National Fire Equipment System Cache Memorandum No. 07-5

Subject: Cargo Swivel Retrofit Project – Final Call

Old Style Spring Hooks

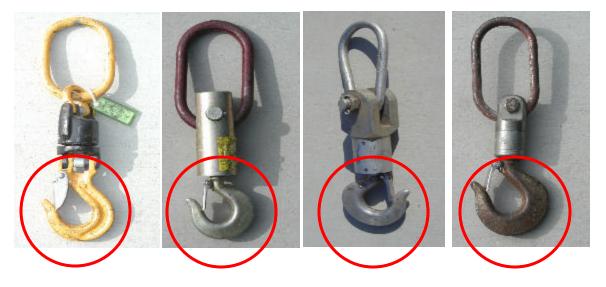
Recent quality control complaints have identified failures of the spring gates on old style (pre-1992 models) 3000 lb cargo swivels (NFES #0526) resulting in the inadvertent release of several sling loads during fire suppression operations. These complaints prompted a review of the various cargo swivel designs currently in use in order to resolve these concerns.

In the early 1990's, the San Dimas Technology and Development Center (SDTDC) evaluated and subsequently recommended a change in the hook design installed on the 3000 lb cargo swivel hook. The typical old style design included a hook with a spring returning gate (see figure 1). Other variations of the old style design can be seen in Attachment 1. The new design uses the gate as part of the load-suspending system through a hinge with the hook part, see figure 2. The improved hook was added to the cargo swivel and the cargo swivel hook assembly has been procured in this configuration since that time.

The first line item is the retrofit of the hook from the spring gate hook to the self-closing under load style hook that has been procured over the last 10 years.

In order to maximize the investment in the older swivels and to take advantage of their inherent durability, the possibility of retrofitting older swivels with the new load closing hooks was investigated. These efforts were successful and have resulted in the establishment of a four-year contract for the retrofit of the old hooks to the newer load closing hook design. Although there are several variations and differing manufacturers of the older spring gate sling swivel, the hook retrofit is compatible with all known patterns of the spring gate design. Retrofitted swivels will be in an "as new" condition in regard to expected service life and function.

Spring gate type swivel assemblies will be accepted for retrofit until December 1, 2007. Ample time is being provided to accomplish the retrofit since the reported occurrence of dropped loads due to spring gated swivels has been determined to be insufficient to identify this problem as a major safety issue. Managers responsible for equipment should make an inventory of their equipment and establish a reasonable schedule for retrofitting their existing swivels to meet the December 2007 deadline. Old style swivels found in use after this deadline shall be removed from the system and scrapped.
